digital INTEROFFICE MEMORANDUM

SUBJECT: PDP-11 I/O Bus

Ref: ES:0002 2 April 1969

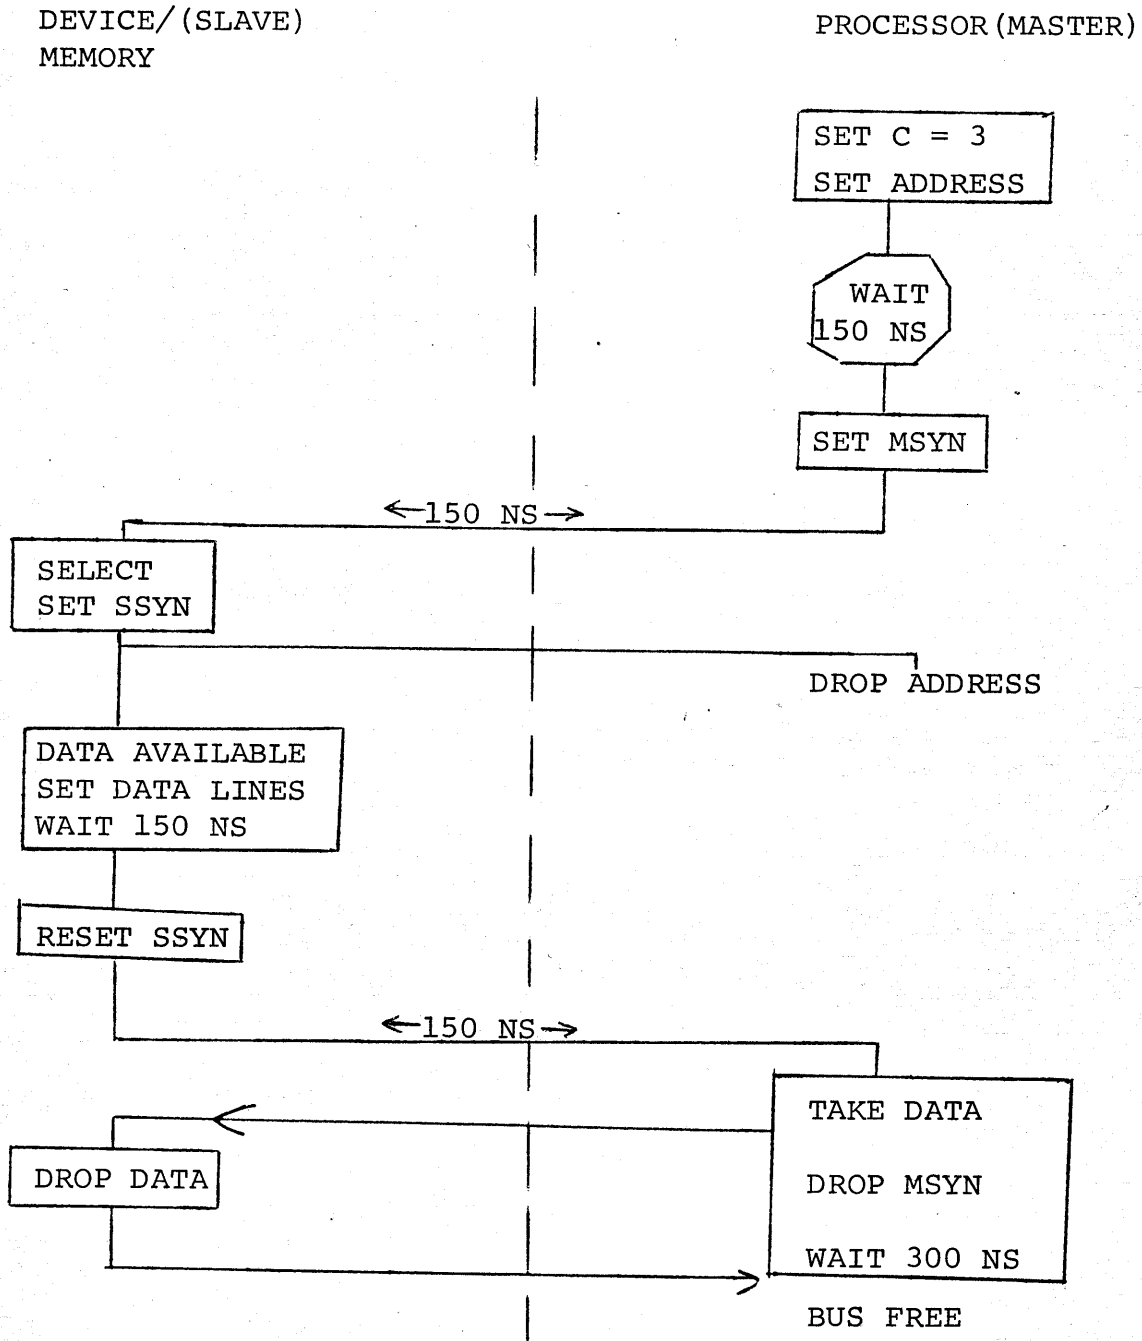
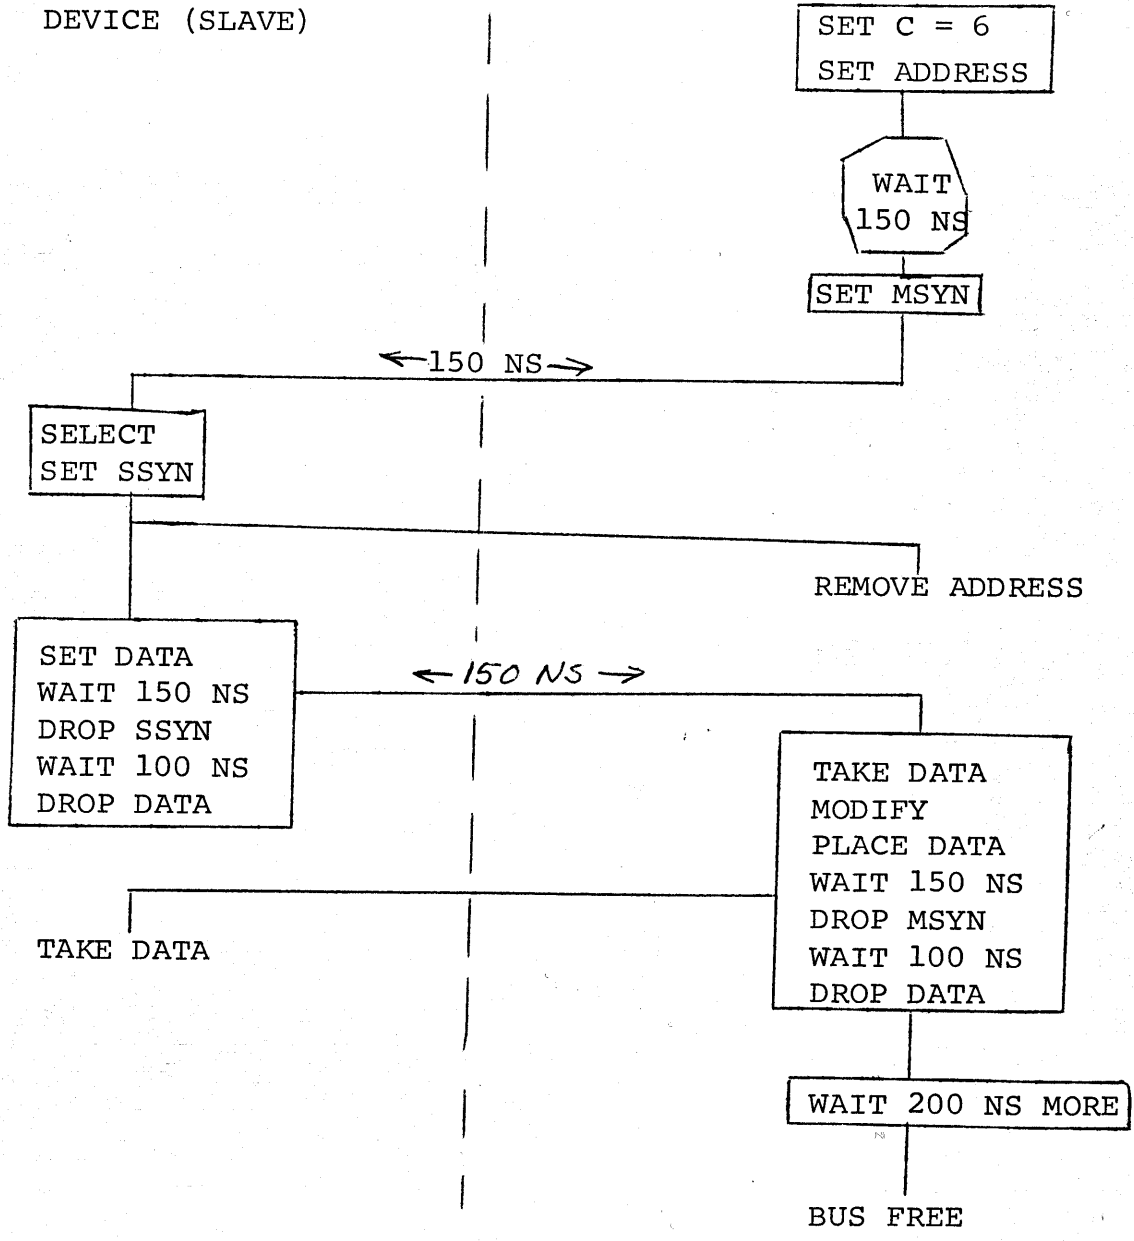
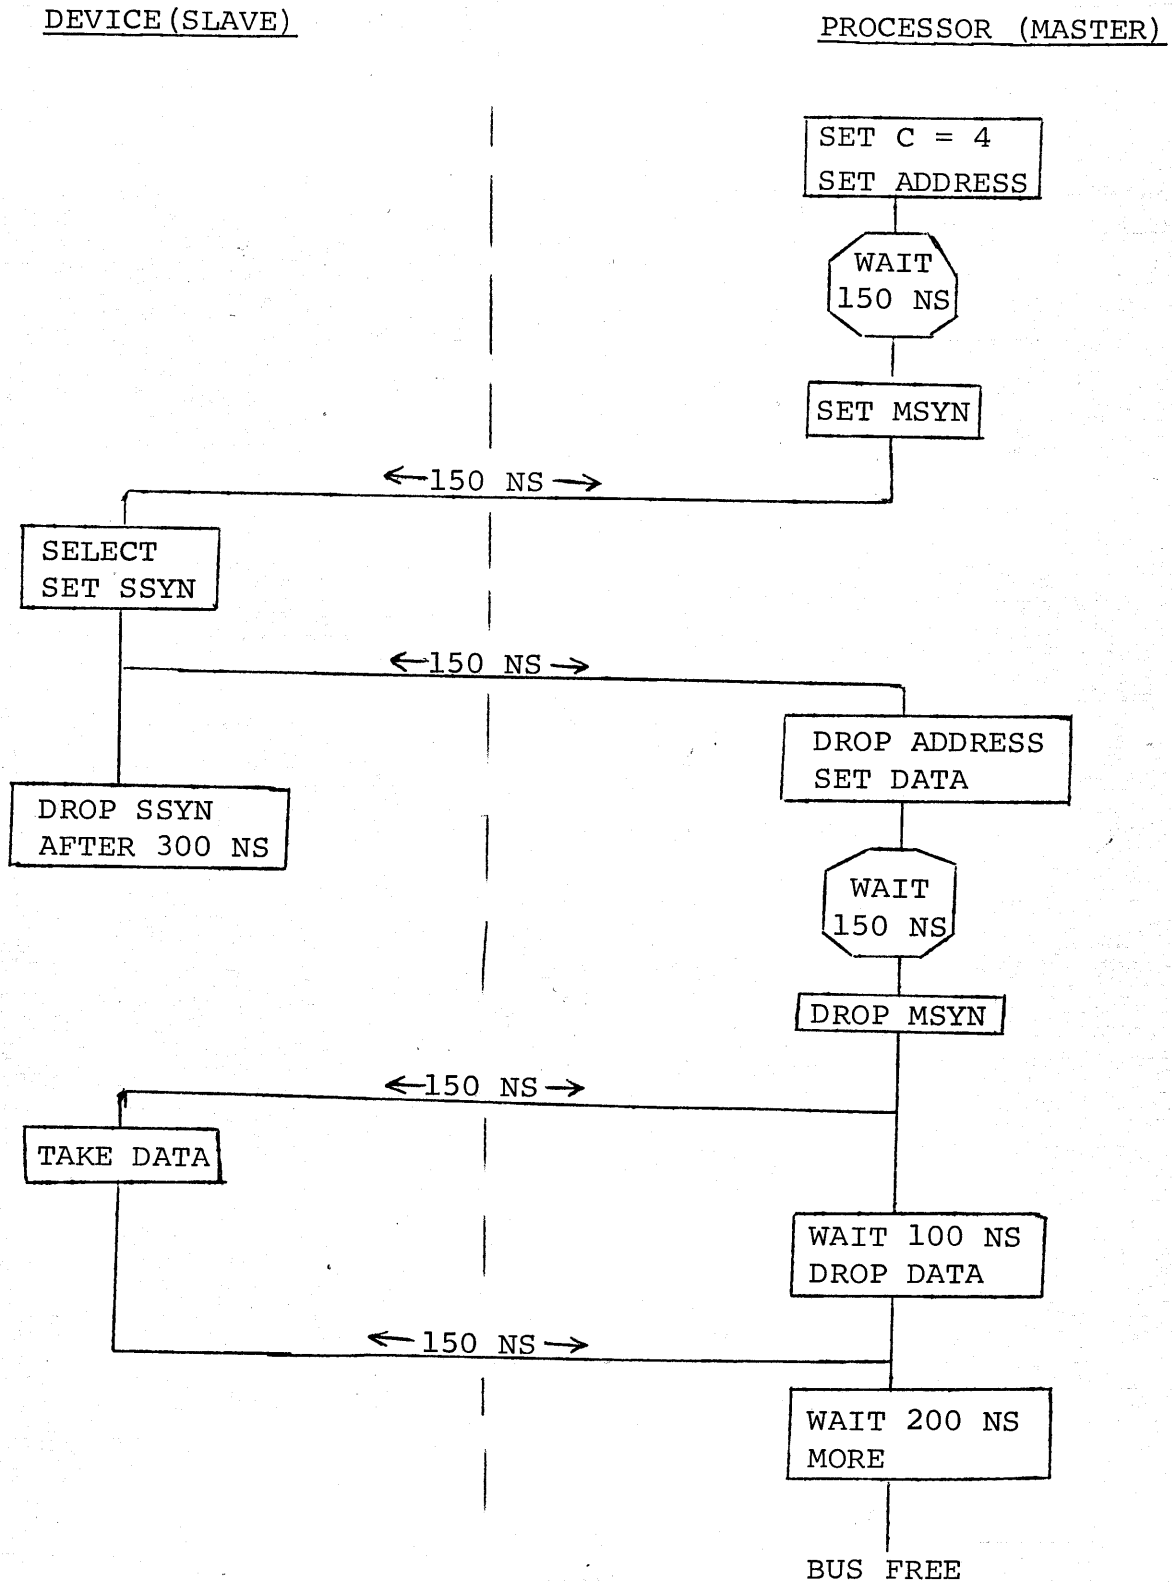
A cursory examination of the bus sequences (see attached
charts) shows typical bus sequence times of .9 to 1.1
usec. Furthermore, these sequences will affect the
minimum instruction cycle time achievable in the system.
Based on guesstimation it looks as if this instruction
cycle time will be limited to approximately 1.3 to 1.5
usec. This may be a serious limitation on larger systems
(or even smaller ones) a few years from now. For
example, look at competition, (SDS Sigma 2,5,7 750 NS -
900 NS, Lockheed Mac 1 usec, PDP-15 800 NS, SEL 810 B
790 NS, etc). Using this type of interlocked bus sequence
bus times can be reduced, by changing things around a bit,
however, not by very much. With a 20 foot limitation on
bus length the PDP-15 memory achieves 700 NS bus sequence
times. with this method.

Also these sequences do not achieve total interlock. If
you want and need total bus interlock considerable
modification is required of your sequences. For example
if your bus length lengthens,delays would have to be
changed in the master devices. With a total interlock
scheme masters and slaves close to the processor would
run fast and ones further out on the bus more slowly with-
out any delay adjustments. It appears to me that this
bus scheme falls short of full interlock and thus a lot
of advantages are lost. At the same time you are paying
for all the disadvantages of an interlocked scheme (slow
communication time, more complex control logic, etc).

1.   The DC Interlock bus scheme is somewhat slow.

2.   The PDP-11 bus doesn't achieve total interlock.

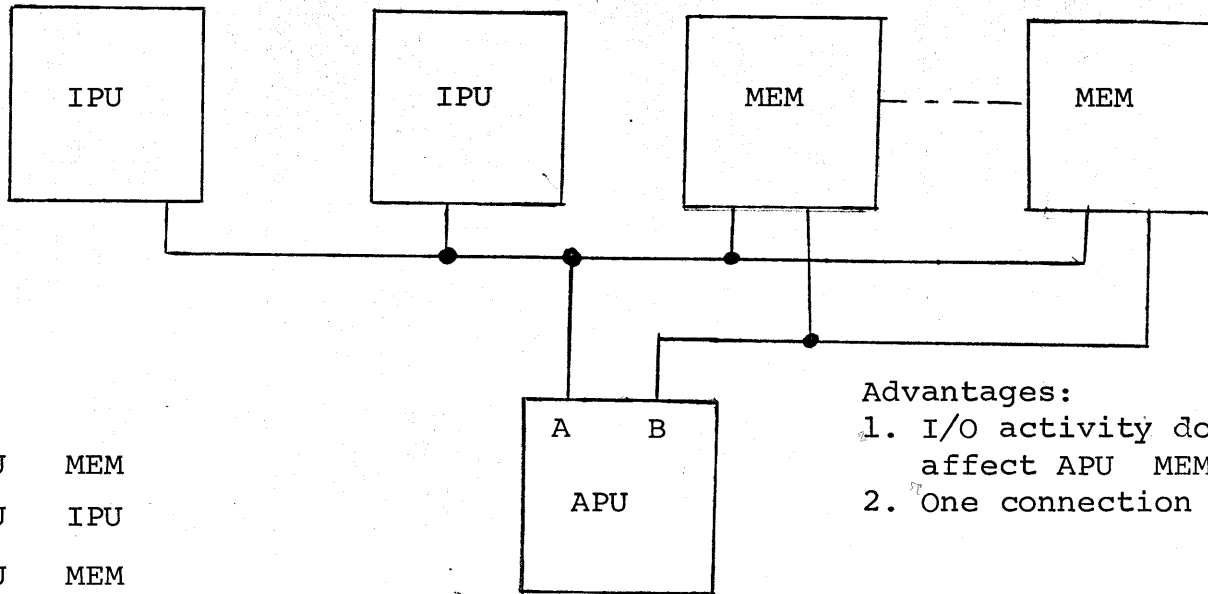
In addition to the basic memory sequencing there are some
I/O limitations - See drawing. In the drawing it is shown
that the fastest back-to-back transfer of data to/from
memory on different devices is one word/byte every 2.4
usec. While doing this the bus is 100% busy, the cpu is
computing but totally locked out of memory and memory is
being used to 50% efficiency. The latency of the system
appears to be the length of a pause (DATM) reference to
memory plus a priority transfer plus half the data transfer

6.   It appears that high I/O rates (stacked up requests) do not use memory at 100% efficiency.

7.   The I/O bus limits back-to-back transfer rates from different devices to ≥2.4 usec between words (this is better than average but we could do better I think).

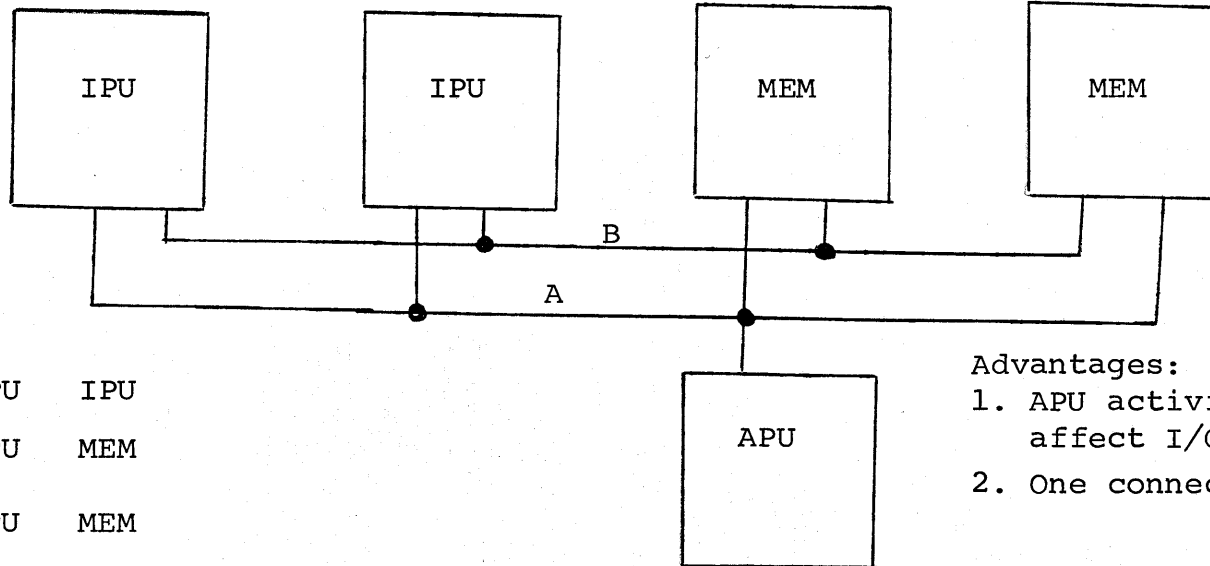
On larger system with lots of I/O gear, multiple memory buses are used to get up to twice the efficiency of use of the memories by allowing high density transfers into one area of memory and calculation programs in another area of memory. I haven't given much thought to adapting your bus to this approach. There are some loose ends though. (Consider who is the master and when on each bus). Two drawings attached show two possible schemes without regard to your particular bus problems.

8.   For larger systems multiple bus configurations should be considered.
